Proposed Aperture (scale 1:25 @ A3)

SCOPE OF WORKS

Proposed Elevation (scale 1:25 @ A3)

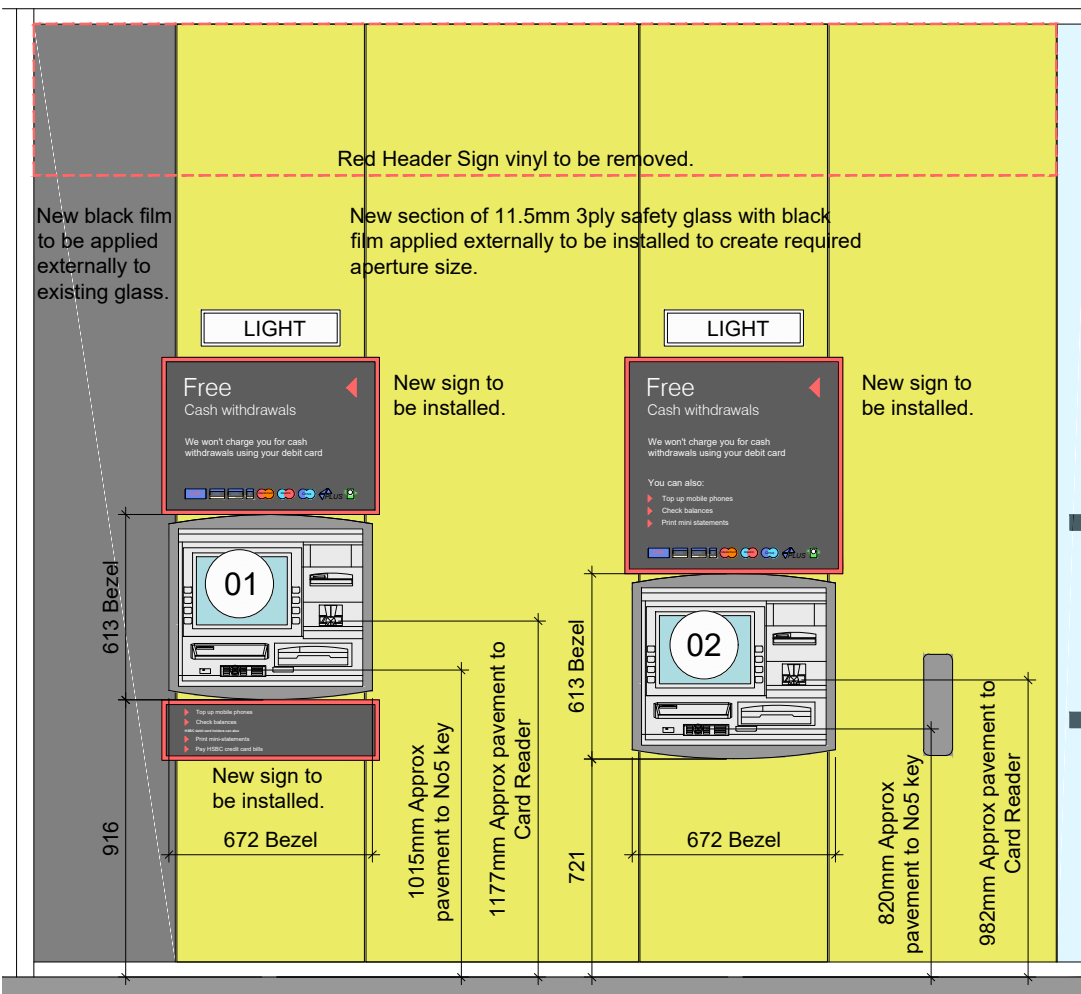
B LIGHTING INDICATED ABOVE ATMS PER PLANNING OFFICER/MET POLICE RECOMMENDATION
 A ATM 02 REPOSITIONED FURTHER TO PRAM NOTES 24/08/16
